# Stage 03: Workgroup Report

# GC0100 EU Connection Codes GB Implementation – Mod 1

This document contains the discussion of the Workgroup formed in June 2017, responses to their consultation and the Workgroup's final conclusions.

Figure 3.15(a) – GB Proposed Voltage Against Time Curve of a Type B Synchronous Power Generating Module showing the conflict with Stage 2 G59 Undervoltage Protection

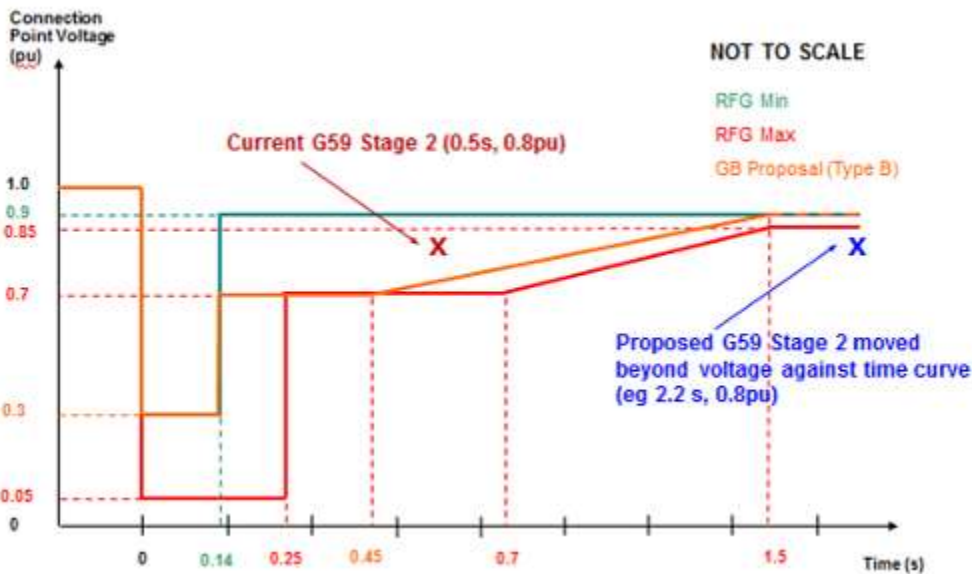
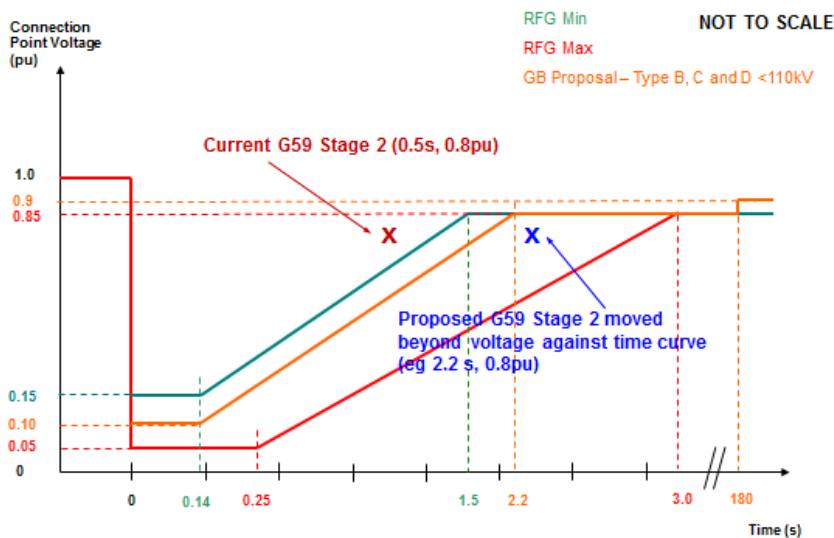
The Workgroup discussed this and The Proposer decided that the best policy for their original solution would be to move the G59 Stage 2 undervoltage protection to 0.8pu at 2.5s. This requirement would apply to all new connecting plant and would be equally applicable to Synchronous Power Generating Modules and Power Park Modules.

It was not believed that changing the G59 Stage 2 Undervoltage protection would cause a significant problem however it was included as a consultation question. The Grid Code/Distribution Code workgroups GC0035 and GC0079 continue to investigate the issues associated with changing RoCoF protection settings for distribution connected generators and have undertaken a risk assessment of Distribution system protection requirements. The analysis for this has been performed by the University of Strathclyde.

The University of Strathclyde were asked to comment on whether the proposed change to a single undervoltage protection would introduce any new risks. Their analysis pointed out that as the RfG only applies to new installations, it does not affect the risk profile for existing plant.

Figure 4.1 (a) Effect of Fast Fault Current Injection Option 2 on clearance time

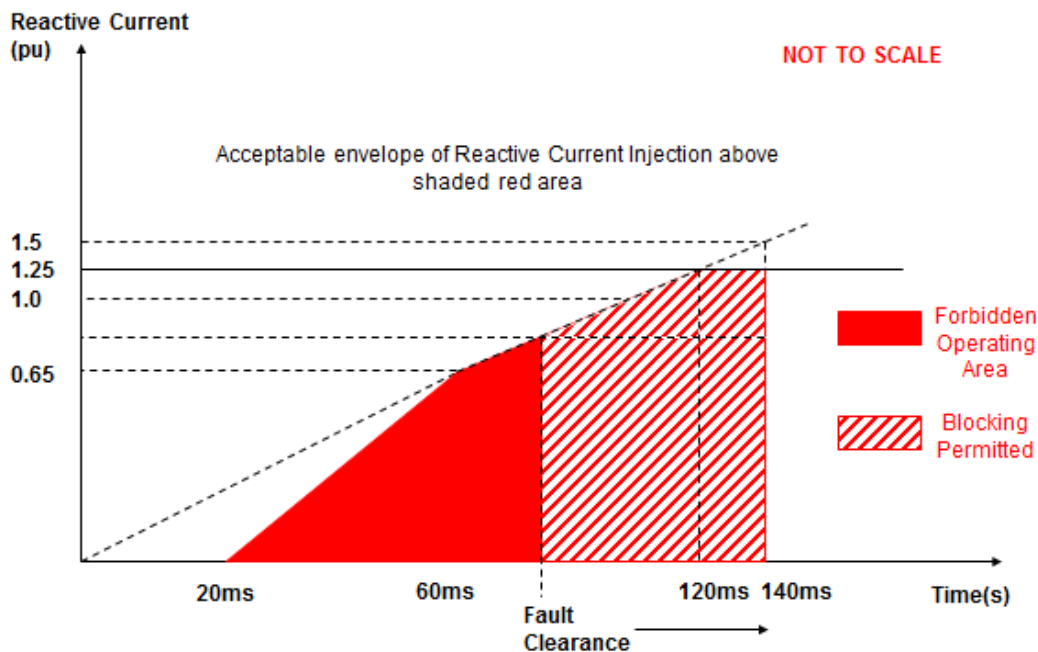
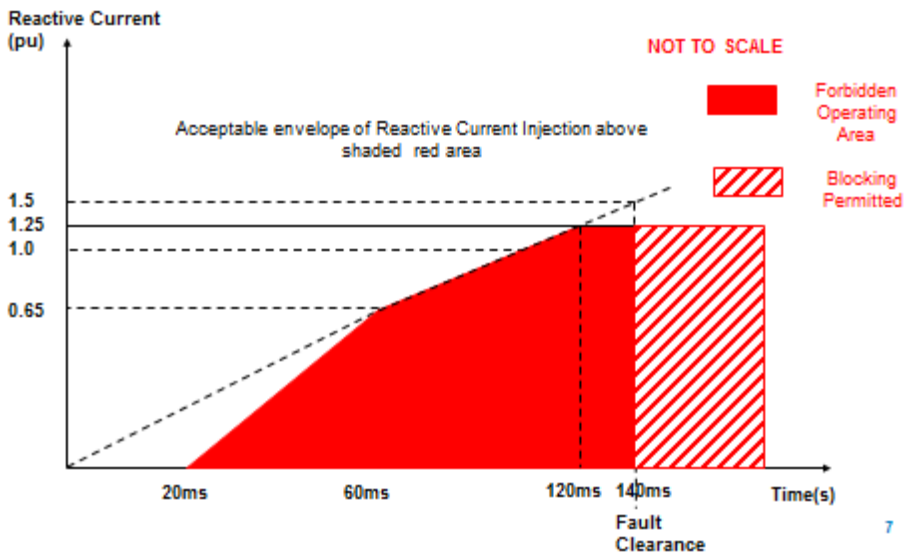
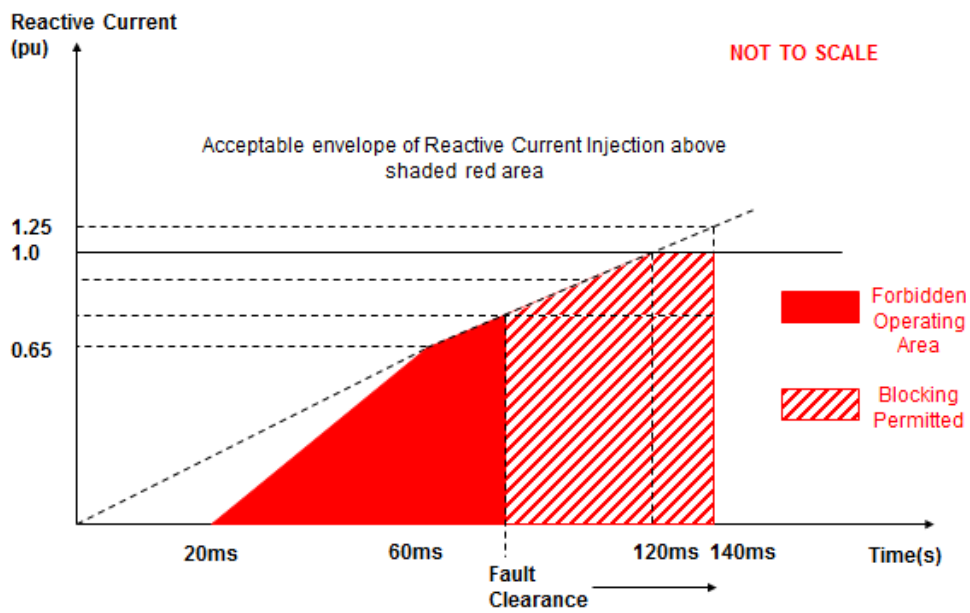
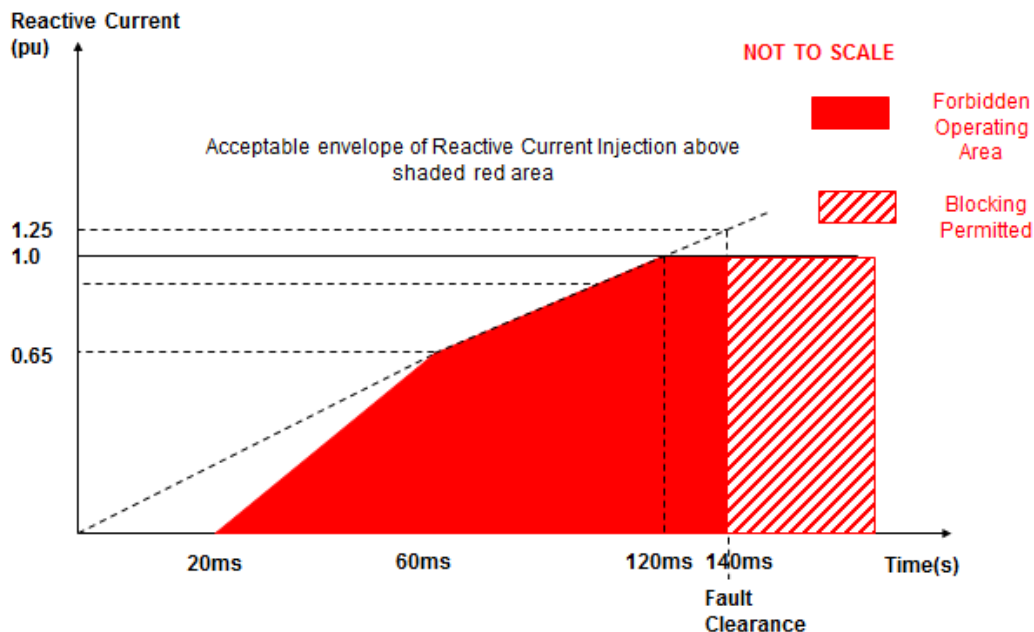
**Option 2** requires a minimum volume of reactive current injection as shown in Figure 4.1(a) and (b). Blocking is permitted on fault clearance to prevent the risk of transient overvoltages). This option would apply to all New Type B and above Power Park Modules which had not signed their contract for major plant items by 17 May 2018 or HVDC Owners who had not signed their contract for major plant items by September 2018.

**Option 3** is a duplicate of Option 2 above but the maximum ceiling current would be limited to 1.0pu as shown in Figure 4.2(a) and 4.2(b). This option would apply to all New Type B and above Power Park Modules which had not signed their contract for major plant items by 17 May 2018 or HVDC Owners who had not signed their contract for major plant items by September 2018.

**Please note** that following the Workgroup Consultation the Proposer has clarified that **Option 3** is their proposed solution which is reflected in the legal text in Annex 1.
